Pole Position II Enhancement Instructions

TM-255 Upright Cabinet

Figure 2 Attraction Glass and Display Shield Replacement

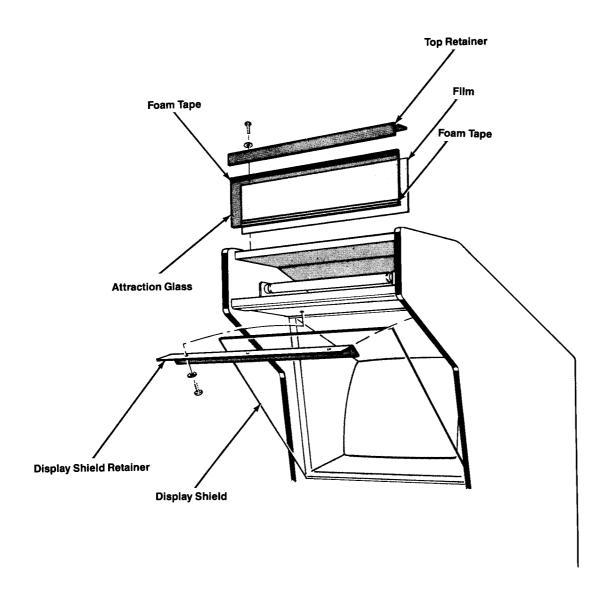
- 1. Use the 1/8-inch Allen wrench to remove the three screws and washers that fasten the top retainer to the cabinet. Remove the retainer. Save the retainer, washers, and screws for reassembly.
- 2. Loosen the three screws that fasten the bottom retainer to the cabinet.
- 3. Remove and discard the attraction glass. If there is a film behind it, remove and discard the film also.
- 4. Take the attraction glass, attraction film, and foam tape out of the enhancement kit. Place a strip of foam tape lengthwise along the top and bottom of the attraction glass. The tape on the glass should be toward you.
- 5. Put the attraction film behind the attraction glass. You should be able to read the film. Place the attraction glass and film in the bottom retainer.
- 6. Tighten the screws in the bottom retainer.
- 7. Reinstall the top retainer, using the washers and screws you saved in step 1.

- 1. Use the 1/8-inch Allen wrench to remove the screws and washers that hold the display shield retainer in place. Save this hardware for reassembly.
- 2. Lift the display shield out of the cabinet.
- 3. Install the display shield contained in the enhancement kit.

Figure 3 Atari PCB Components Affected by Enhancement

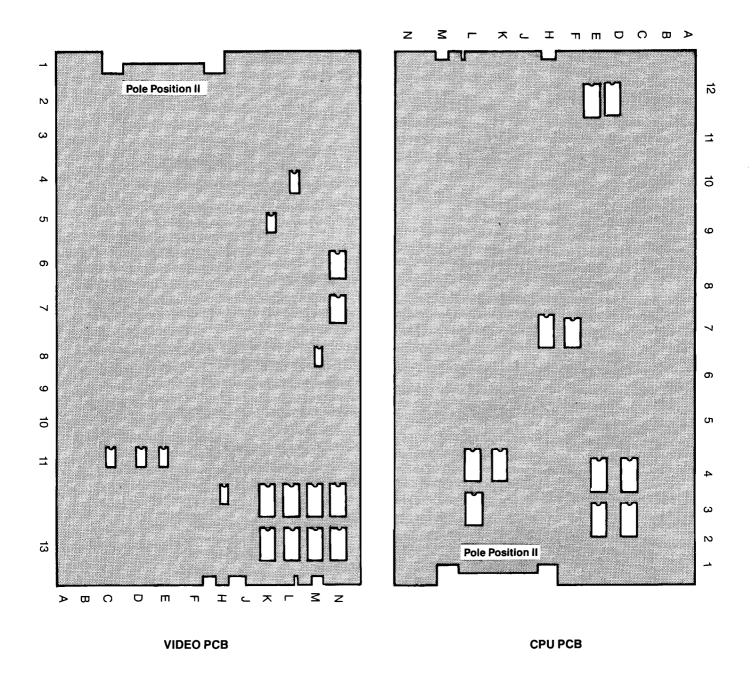
1. Using the method shown in Figure 9, remove the integrated circuits at locations 3E, 3L, 4E, 4L, 7F, 7H, 12E, and 12F from their sockets.

- 2. Using the proper soldering techniques, remove the solder from the plated-through holes at locations 3D, 4D, and 4K.
- 3. Remove three 28-contact IC sockets from the enhancement kit and install them on the PCB at locations 3D, 4D, and 4K. Be sure to observe the proper placement of the socket index as shown on the PCB.
- 4. Using the information given in Table 4, remove each specified IC from the enhancement kit and install it in the proper socket.

- 1. Using the method shown in Figure 9, remove the integrated circuits at locations 6N, 7N, 12K, 12L, 13K, 13L, and 13N from their sockets.
- 2. Using the method given under "Removing Integrated Circuits," remove the soldered-in IC at locations 4L, 5K, 8M, 11C, 11D, 11E, and 12H.
- 3. Remove the 24-contact IC sockets from the PCB at locations 6N and $7N_{\bullet}$
- 4. Using the information given in Table 5, remove the appropriate IC sockets from the enhancement kit and install each in the specified location.

Table 4 Atari CPU PCB Component Locations

IC Part No.	CPU PCB Location
136014–176	3L
136014-177	4L
136014-178	3E
136014–179	4E
136014180	7н
136014–181	1 2 F
136014-182	12E
136014–183	7 F
136014-184	3D
136014–185	4 D
137351-001	4K

Table 5 IC Socket Locations on the Atari Video PCB

No. of Contacts	Install at Location:	
16	5K	
16	8M	
16	11C	
16	11D	
16	11E	
18	4 L	
18	12H	
28	6N	
28	7N	
28	12M	
28	13M

Table 6 Atari Video PCB Component Locations

IC Part No.	Video PCB Location
136014–166	13K
136014-167	12K
136014-168	13L
136014–169	12L
136014-170	13N
136014-171	12N
136014-172	7N
136014–173	6N
136014-174	12M
136014-175	13M
136014-186	11E
136024–187	11D
136014188	11C
136014-189	8M
136014-190	5K
136014-191	4L
136014-192	1 2 H

Figure 4 Namco PCB Components Affected by Enhancement

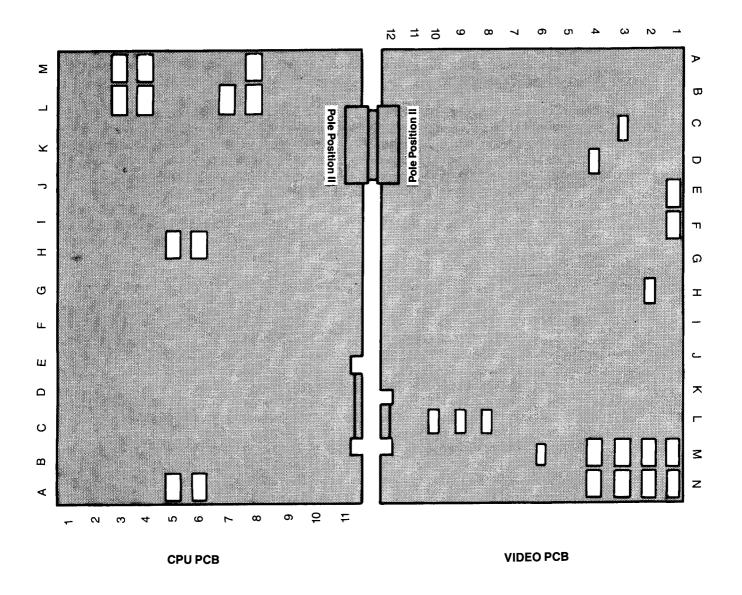
1. Using the method shown in Figure 9, remove the integrated circuits at locations 4M, 8M, 4L, 8L, 5H, 6H, 5A, and 6A from their sockets.

- 2. Using the proper soldering techniques, remove the solder from the plated-through holes at locations 3M, 3L, and 7L.
- 3. Remove three 28-contact IC sockets from the enhancement kit and install them on the PCB at locations 3M, 3L, and 4L. Be sure to observe the proper placement of the socket index as shown on the PCB.
- 4. Using the information given in Table 7, remove each specified IC from the enhancement kit and install it in the proper socket.

- 1. Using the method shown in Figure 9, remove the integrated circuits at locations 1E, 1F, 4M, 3M, 1M, 4N, 3N, and 1N from their sockets.
- 2. Using the method given under "Removing Integrated Circuits," remove the soldered-in IC at locations 3C, 4D, 2H, 10L, 9L, 8L, 6M, and 2N.
- 3. Remove the 24-contact IC sockets from the PCB at locations 1E and 1F.
- 4. Using the information given in Table 8, remove the appropriate IC sockets from the enhancement kit and install each in the specified location.

Table	7	Mamoo	ו זפי	D/D	Commonant	Locations
Table		Namco	CPU	PUR	Component	LOCATIONS

IC Part No.	CPU PCB Location	
136014-176	8M	
136014-177	8L	
136014-178	4 <u>M</u>	
136014–179	4L	
136014-180	6Н	
136014-181	6A	
136014-182	5A	
136014–183	5н	
136014-184	3M	
136014-185	3L	
137351-001	7 L

Table 8 IC Socket Locations on the Namco Video PCB

No. of Contacts	Install at Location:	
16	2H	
16	8L	
16	9L	
16	10L	
16	4 D	
18	6M	
18	8C	
28	1E	
28	1F	
28	2M	
28	2N

Table 9 Namco Video PCB Component Locations

IC Part No.	Video PCB Locations	
136014-166	4N	
136014-167	4M	
136014-168	3N	
136014–169	3M	
136014-170	1N	
136014-171	1M	
136014-172	1 F	
136014–173	1E	
136014-174	2M	
136014-175	2N	
136014-186	8L	
136014–187	9L	
136014-188	10L	
136014-189	2н	
136014-190	4D	
136014-191	3C	
136014-192	6M

Figure 10 Display Shield Replacement—Sit-Down

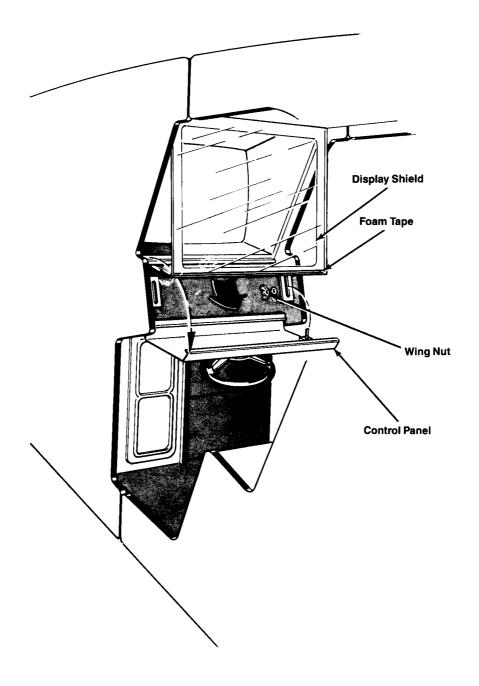
- 1. Open the access panel at the rear of the game.
- 2. Reach toward the front of the game, and remove the wing nuts and washers that secure the control panel to the game cabinet. (Someone should hold the control panel against the cabinet as you do this!) Save this hardware for reassembly later.
- 3. Pull the bottom of the display shield toward you. Remove and discard this shield.
- 4. Apply a strip of foam tape to the front bottom of the display shield provided in the enhancement kit.
- 5. Insert the Pole Position II display shield. Close the control panel. Someone should hold the control panel against the cabinet as you reinstall the hardware.
- 6. From behind the cabinet, reinstall the wing nuts and washers you saved in step 1.
